SAFETY RECALL CAMPAIGN ANNOUNCEMENT

Subject: **Voluntary Safety Recall Campaign 70D4/J6
2009 Audi Q5 vehicles
Replace Middle Clip of A –Pillar Cover**

Safety Recall Circular

Replace Middle Clip of A-pillar Cover

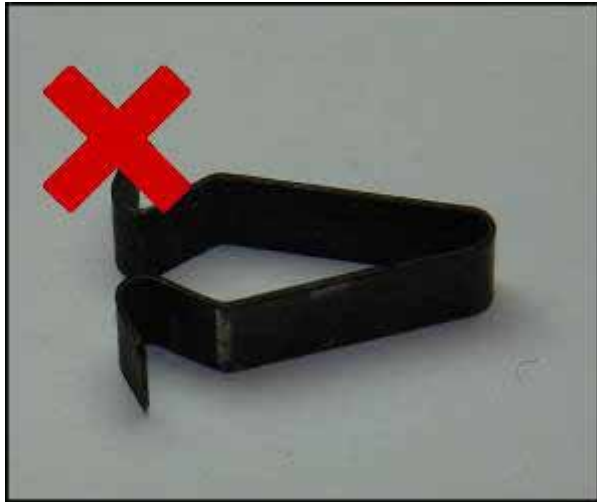
- ⇐ Remove center retaining clip -circle- and install new retaining clip part number (8Z0 867 276)

Tip: If center trim clamp -circle- remains in the body mounting, remove and discard trim clamp

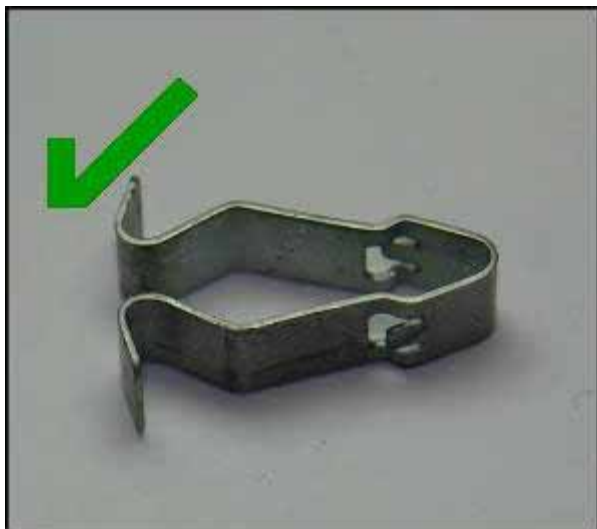
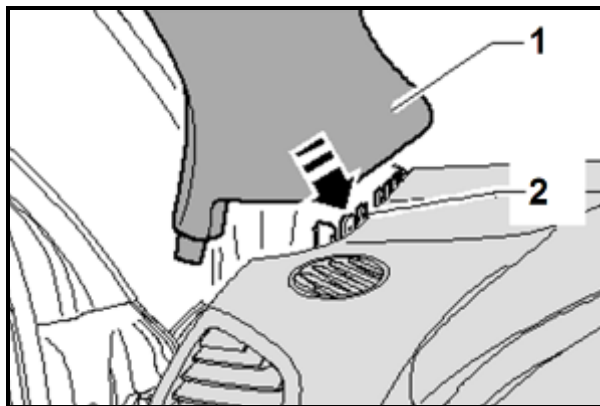
Tip: Old retaining clip (must be removed)

Tip: New retaining clip part number
(8Z0 867 276)
